**REMARKS**

Claims 14-15 and 17-21 are pending in this application. By this Amendment, the specification and claims 14-15 and 17-19 are amended, claims 13 and 16 are cancelled, and claims 20-21 are added. Further, the drawing Figs. 11, 13, 22 and 27 are corrected and replaced by the attached Replacement Drawing Sheets. Reconsideration based on the above amendment and the following remarks is respectfully requested.

**FIG. 11**

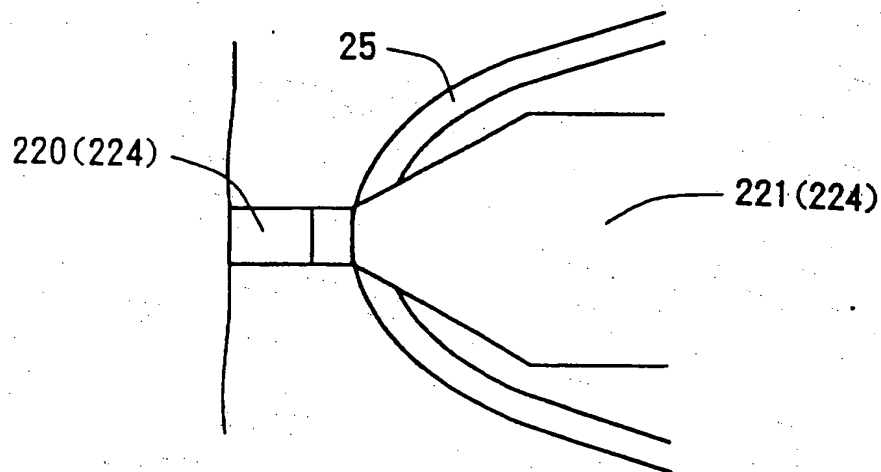
The Office Action objects to the drawings. Specifically, the Office Action asserts that the yoke part 221 disclosed on page 20, line 28, of the specification is not shown in the drawings. The objection is respectfully traversed.

The yoke portion 221 is shown in Figs. 2, 3 and 6-10, but is not shown in Figs. 11 and 13. However, Figs. 11 and 13 are corrected to indicate the yoke portion 221 in light of the description of Figs. 11 and 13 in the specification. Since the pole part 220 and the yoke part 221 are formed by the same magnetic film 224, there is no defined boundary line separating the pole part 220 and the yoke part 221.

Figs. 11, 13, 22 and 27 are also corrected as indicated in the attached Replacement Drawings Sheets to correct informalities. Withdrawal of the objection to the drawings is respectfully requested.
